Cabarrus County Planning and Zoning Commission Meeting
March 10, 2020 @ 6:30 P.M.
Board of Commissioners Meeting Room
Cabarrus County Governmental Center

Re: Cabarrus Memorial Gardens – ARCH2018-00001

**Proposed Changes to Approved Building Plans for ARCH2018-00001
 Design Review Standards Staff Report**

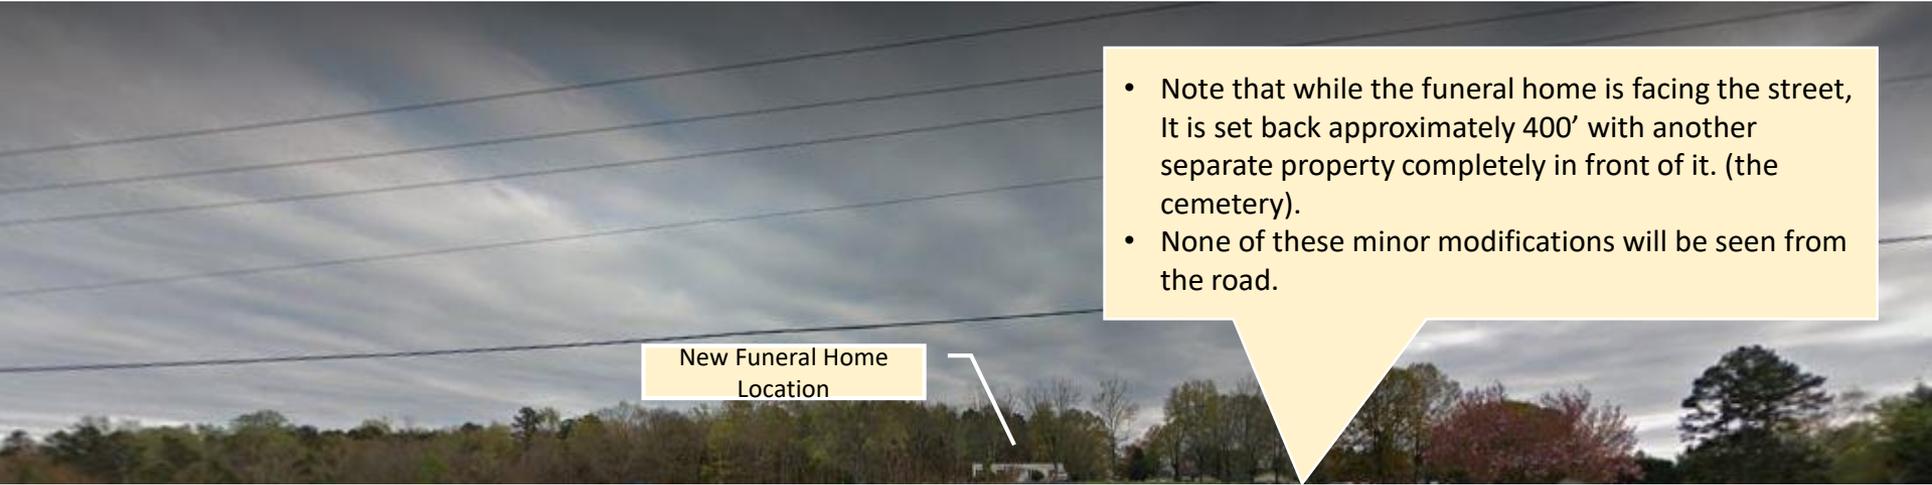
The canopies have been modified from open faced timber to using the same cement based material that has been used on the rest of the building. The change was made because of the concern for the elderly and frail funeral attendees that will often be under these canopies. With the open faced design birds and bees would likely nest in the open faced timbers and the concern was that there would likely be bird problems including droppings, nests, and dive bombing birds as well as wasp and beetles. See "Site Plan Modification – Gables Modifications" Page 1 & 2 in the separate PowerPoint presentation.

Exterior Door Modification

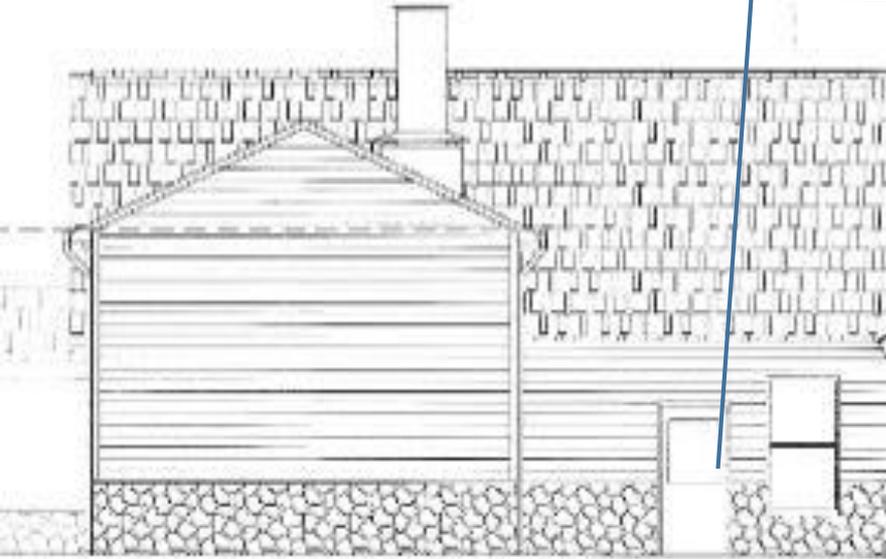
- Door Eliminated

Non emergency exit with no purpose. Would have opened directly into the electrical area where we do not want people wandering. Main back door is approximately 15' away with clear interior passage.

SHEET
A-5
TOTAL # OF SHEETS

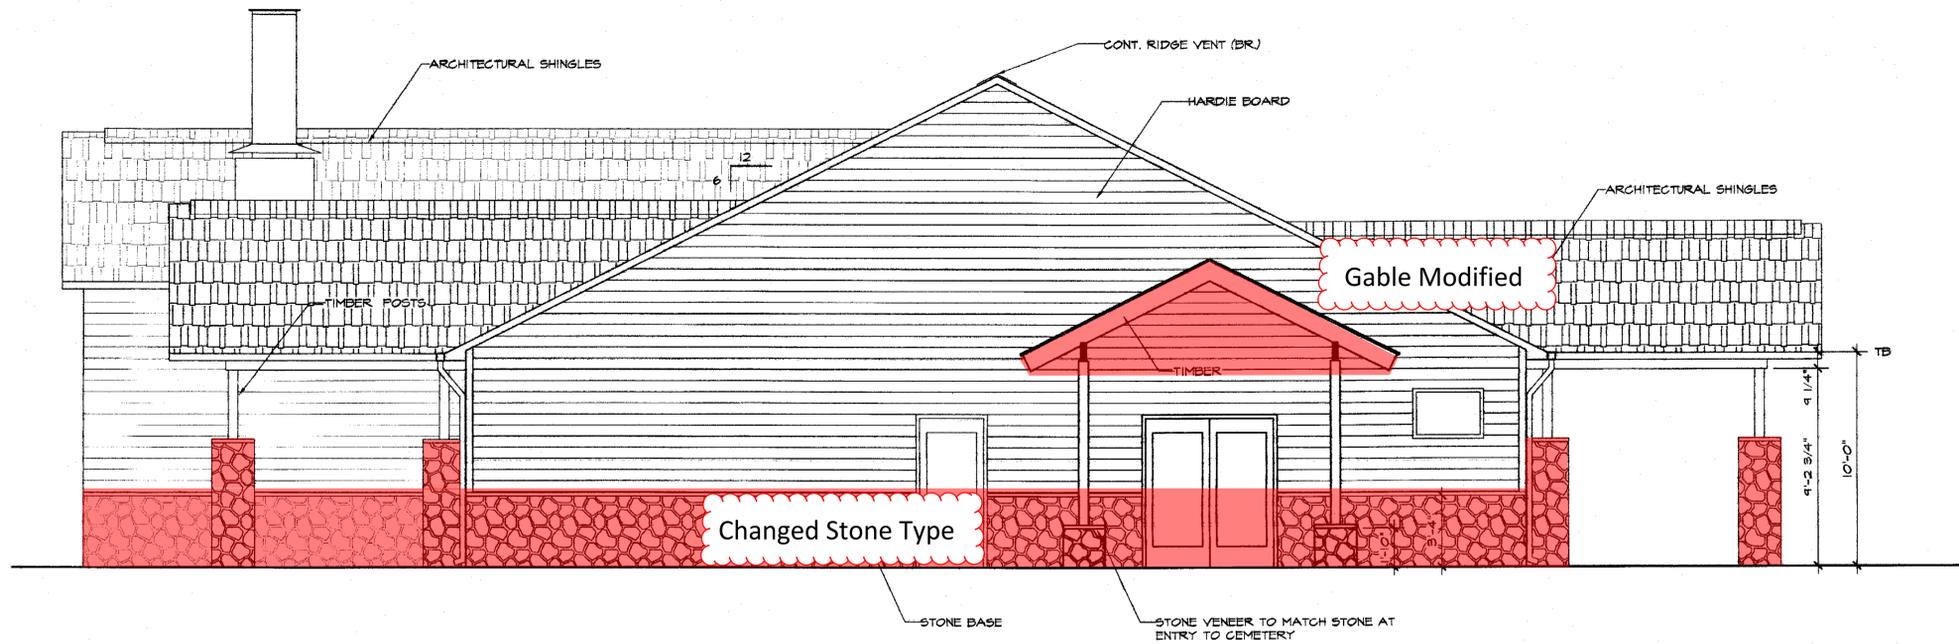
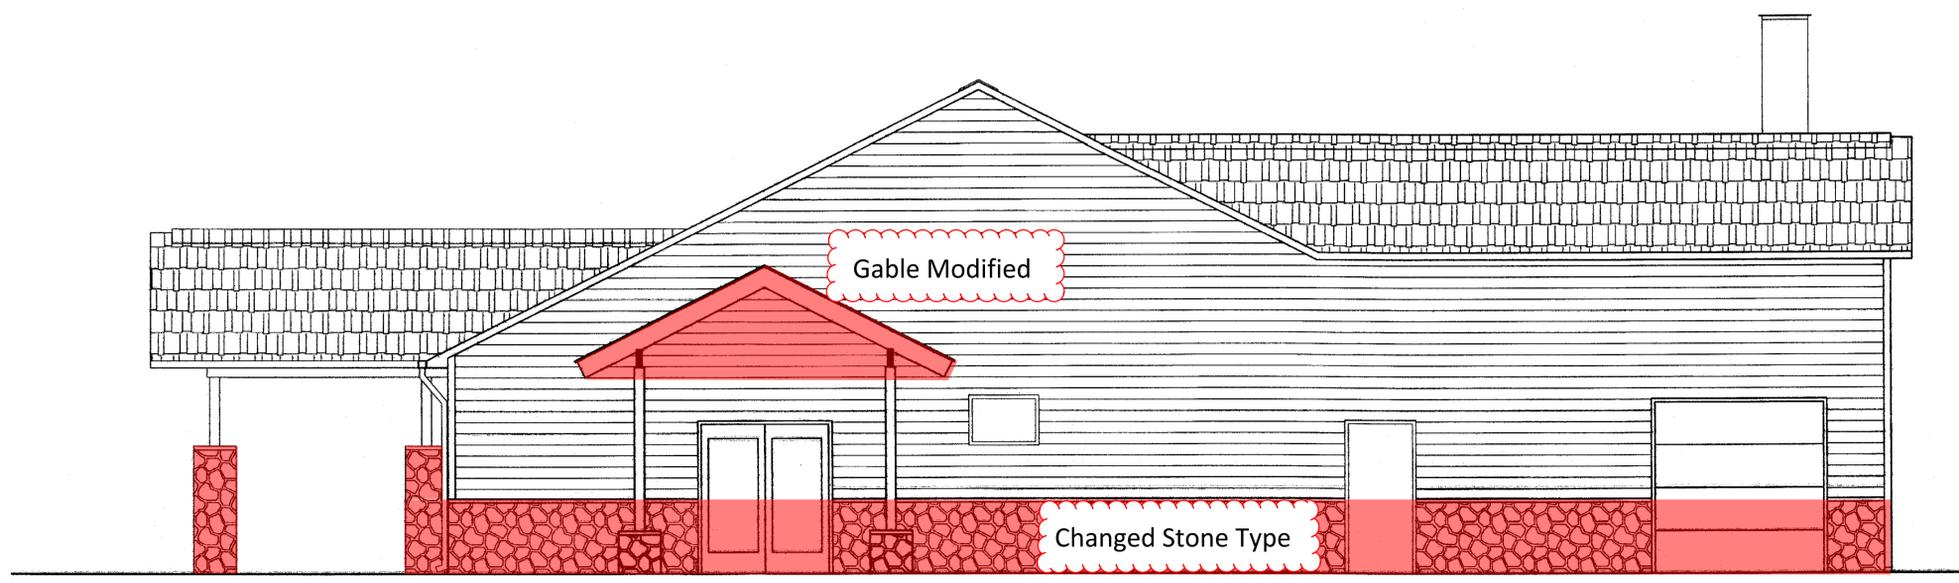
All windows and entrances facing rights-of-ways are transparent. There are four entrances and nine exits (two emergency exits in each visitation room and one in the banquet hall). All windows are transparent with the exception of the emergency exit door windows and the preparation room clerestory located on the western side of the structure and shown on sheet A-5 of the site plan (bottom elevation).
